PROJECT NAME:	Newport Harbor High School Pool Equipment Replacement			
PROJECT NUMBER:	103-21			
	Jonathan Geiszler, Director			
TO:	of Purchasing & Warehouse EMAIL: jgeiszler@nmusd.us

DATE:	11/24/2020			
FROM:		Crews, Estimator lifornia Waters	EMAIL:	bcrews@californiawaters.com
DOCUM NUMBE	ENT/DIVISION R:	Section 131105 2.02.B	DRAWING NUMBER:

DATE:	11/2	4/2020		
FROM:		ws, Estimator nia Waters	EMAIL:	bcrews@californiawaters.com
DOCUM NUMBE	ENT/DIVISION R:		DRAWING NUMBER:	Sheet SP1.4 / Detail 5

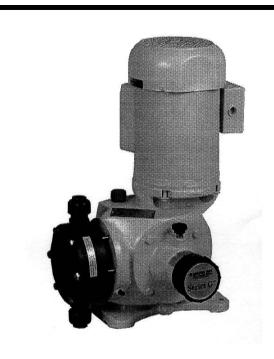
Detail 5 on sheet SP1.4 show chemical pump detail. Notes states "(under 30 pounds)". the LMI SD43-88P-KSI chemical pump specified weighs 45 pounds (see attached product sheet). Please provide clarification on mounting.

Mounting detail is applicable for an LMI pump weighing 45 pounds. Pump shelf shall be installed as shown.
